# UNITED STATES PATENT AND TRADEMARK OFFICE

APPLICATION NO.	FILING DATE	FIRST NAMED INVENTOR	ATTORNEY DOCKET NO.	CONFIRMATION NO.
10/711,842	10/08/2004	Markus Reiter	20067US	5841
23470	7590	05/13/2009		
SRAM, LLC 1333 N. KINGSBURY, 4TH FLOOR CHICAGO, IL 60642			EXAMINER IRVIN, THOMAS W	
			ART UNIT 3657	PAPER NUMBER
			NOTIFICATION DATE 05/13/2009	DELIVERY MODE ELECTRONIC

<b>Office Action Summary</b>	<b>Application No.</b> 10/711,842	<b>Applicant(s)</b> REITER, MARKUS	
	<b>Examiner</b> THOMAS W. IRVIN	<b>Art Unit</b> 3657

**FIG. 12**

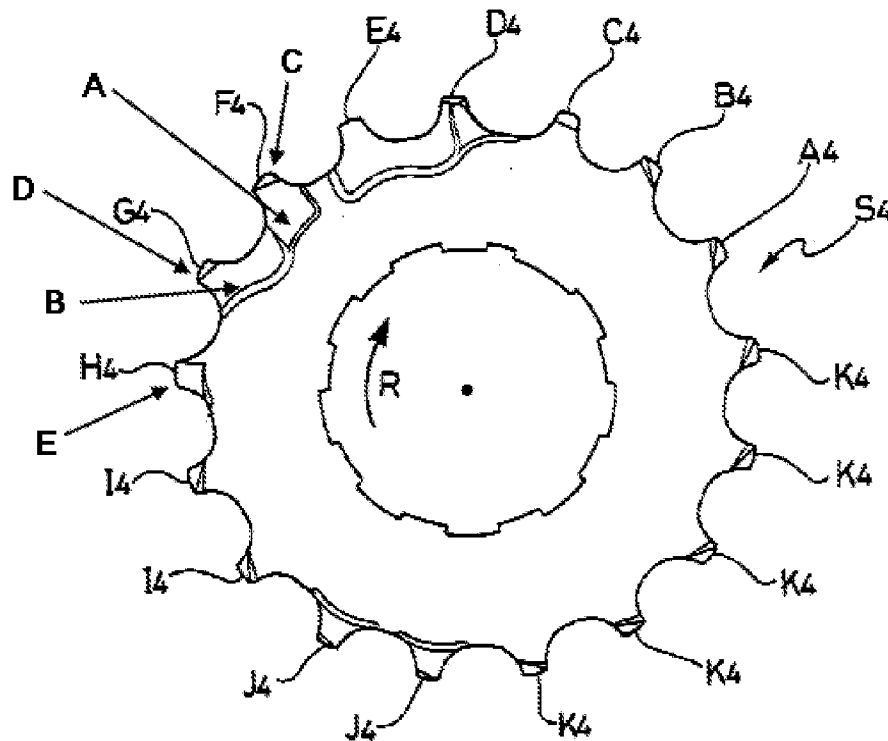
In Re claim 1, with reference to Fig. 3, 13, 14, and 12 (above), Kamada discloses a chainwheel assembly including a plurality of chainwheels (s1-s7) engageable with a chain (23) having successive alternating pairs of inner link plates and outer link plates connected by pins, the pins surrounded by rollers, the chainwheel assembly comprising: at least one smaller chainwheel (s3) having a plurality of teeth spaced about its circumference; and at least one larger chainwheel (s4) having a greater number of teeth spaced about its circumference than the smaller chainwheel, the larger chainwheel and the smaller chainwheel oriented relative to each other such that a distance between a center of the chain roller positioned between a pair of adjacent teeth on the larger chainwheel and the center of the chain roller between a pair adjacent teeth on the smaller chainwheel is substantially an integer multiple of the chain pitch, at least a first tooth (f4) of the pair of adjacent teeth (F4,G4) on the larger chainwheel includes a first lateral recess (A) having a first run-on ramp (see fig. 14), at least a second tooth (G4) of the pair of adjacent teeth disposed adjacent to the first tooth opposite the drive rotation direction including a second lateral recess (B) with a run-on ramp (see fig. 14).

In Re claims 8, 9, and 12, see deflection chamfers (C,D) on the first and second tooth (F4,G4) in fig. 12 above.

**FIG. 5**

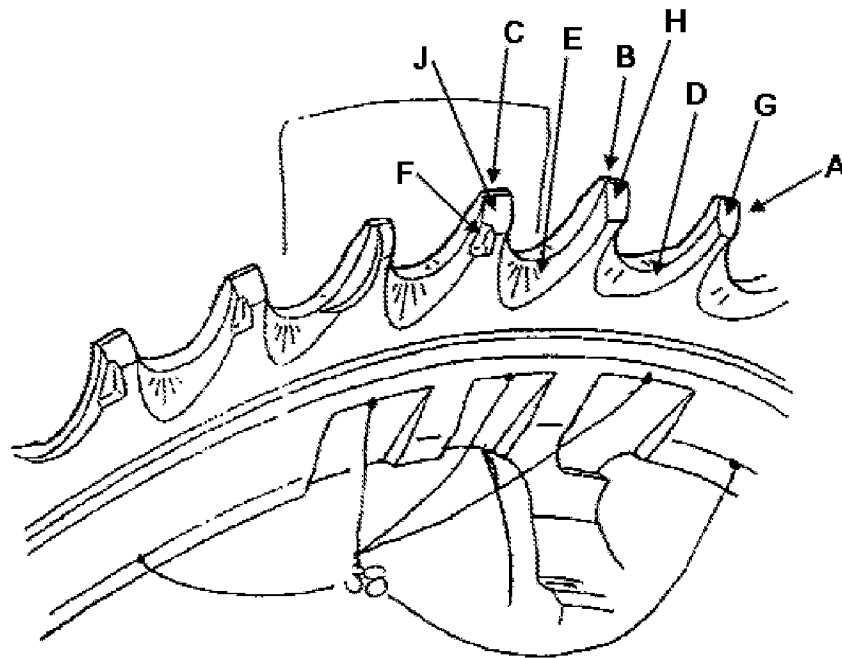
In Re claim 1, with reference to Fig. 5, above, Yahata discloses a chainwheel assembly including a plurality of chainwheels (see fig. 15) engageable with a chain (10), the chainwheel assembly comprising: at least one smaller chainwheel (50) having a plurality of teeth spaced about its circumference; and at least one larger chainwheel (40) having a greater number of teeth spaced about its circumference than the smaller chainwheel, at least a first tooth (A) of a pair of adjacent teeth (A,B,C) on the larger chainwheel includes a first lateral recess and run-on ramp (D), at least a second tooth (B) of the pair of adjacent teeth disposed adjacent to the first tooth opposite the drive rotation direction including a second lateral recess and run-on ramp (E).

In Re claims 8 and 12, see deflection chamfers (G,H) on the first and second tooth (A,B) in fig. 5 above.
